Rezoning Transportation Analysis

Petition Number: 2025-004

Date	Description
02-26-25	First Review (NK)
08-20-25	Second Review (NK)
11-20-25	Third Review (NK)

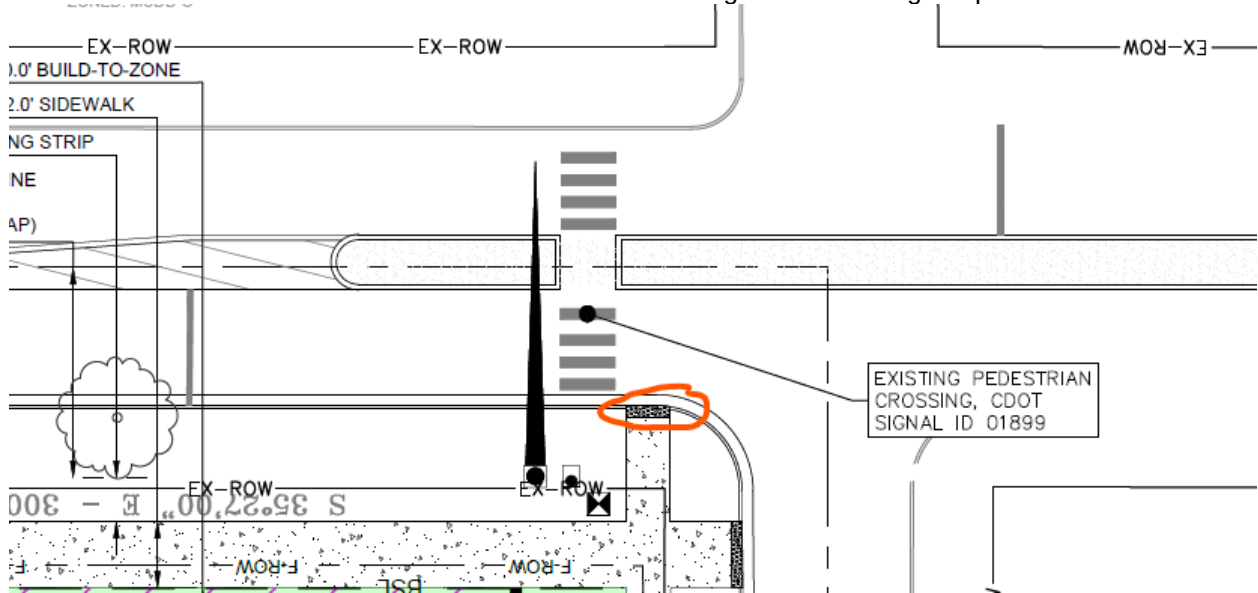
16. **New Comment 11.19.25:** Shift crosswalk shown below to align with receiving ramp.
